CONSERVATION TEAM CONSULTATION APPLICATION RESPONSE

APPLICATION REF:	25/02515/LBC & 25/02596/FPH
CASE OFFICER:	VW
APPLICATION SITE:	Old Manor House, Shaftenhoe End, Bogmoor Road Barley, Royston, Hertfordshire SG8 8LE
DESCRIPTION OF WORKS:	Extend south gable end, change cladding, and alter fenestration of existing west extension. Internal and external alterations including installation of air source heat pump on west elevation of existing west extension.

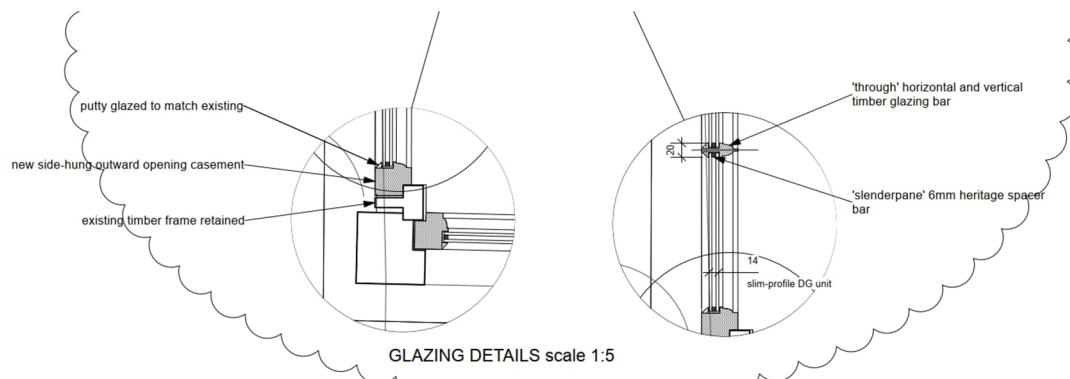
Removal of porch and front doors and reinstatement of traditional canopy

The proposed fanlight over the front door has been revised to a simple single pane.

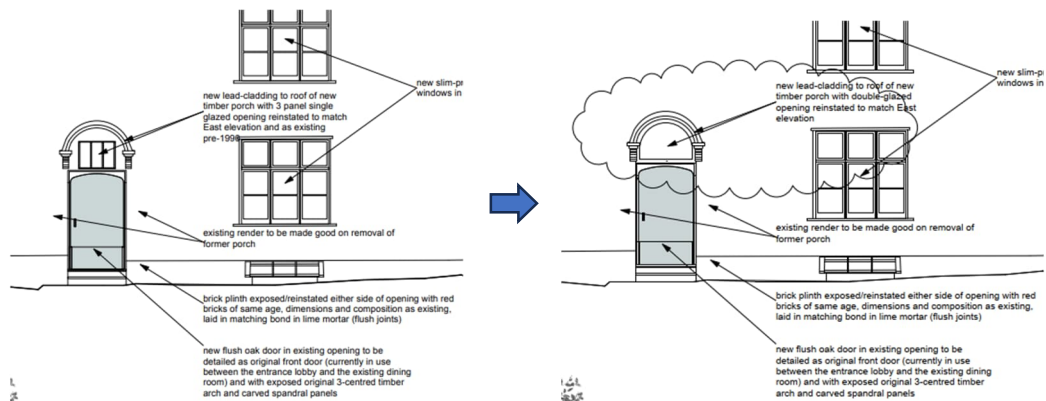
In my response on 27 November 2025, I stated that I found the 3-pane rectangular fanlight to the former opening a little incongruous and that a semi-circular fanlight may be better, offering the following as suggestions.

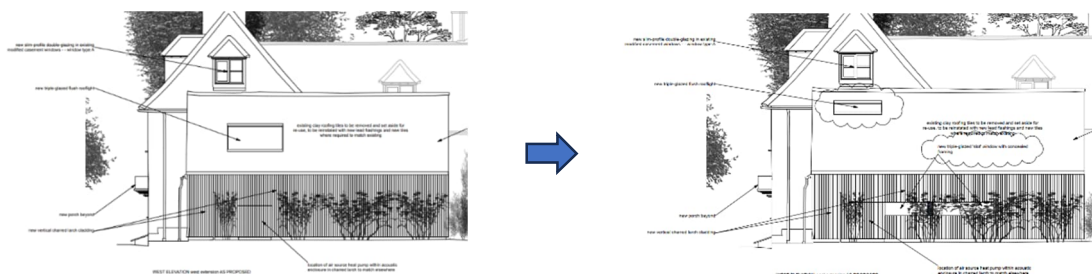
I find the suggested change below acceptable.

Dressing room adjoining Master Bedroom to be converted into a shower room

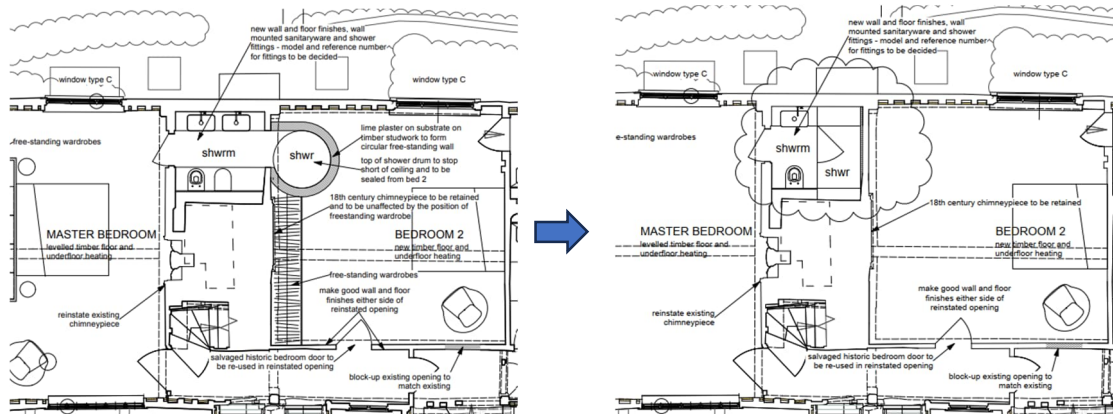
I previously stated that this is arguably the most contentious element of the scheme, concluding that the degree of harm to this room would be low/moderate. Consequently, I have sought a change. I note below that the drum shower has been omitted as have all wardrobes in both the master bedroom and bedroom 2. This is now acceptable.
